PREVOST

IS-11003A

“MASTER ID” REPLACEMENT WITH “MCM” MODULE

REVISION: A THIS INSTRUCTION SHEET SUPERSEDES PREVIOUS VERSION.

FIGURE 5

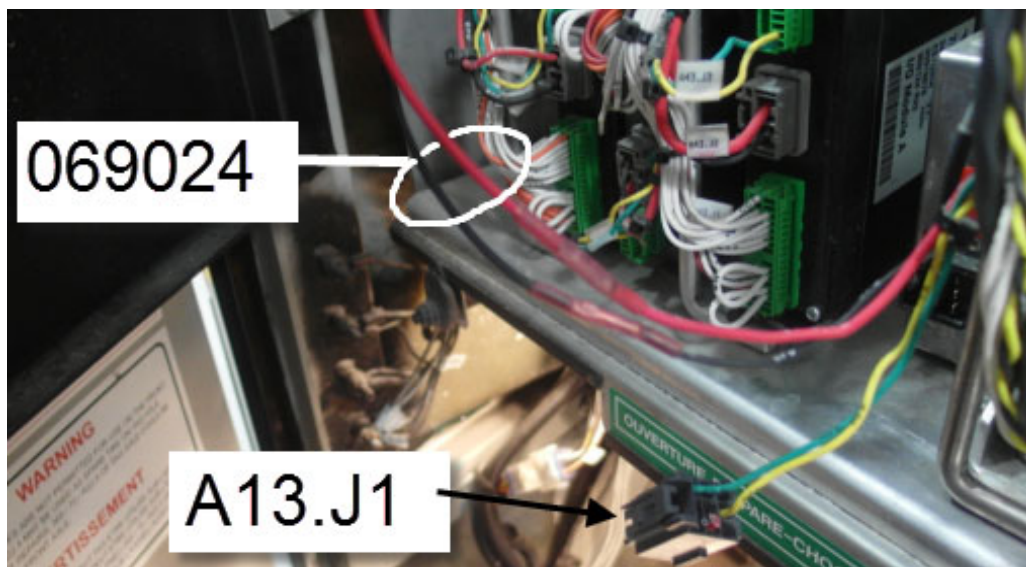
Step 7, addition of comment about missing butt splices.

6. Cut circuits 24 WUP (red) & GND (black) at the Master ID connector A13.J1.
7. Crimp circuit 24VI (red) & GND2 (black) of harness 069024 to circuits 24 WUP (red) & GND (black) respectively of Master ID connector A13.J1 (see FIGURE 5). Heat up each butt splice shrinking sleeve

(Butt splices may not be installed on first version of this harness, in that situation, use butt splice #563622 if available (2 needed) or solder and cover with heat shrinking sleeve).
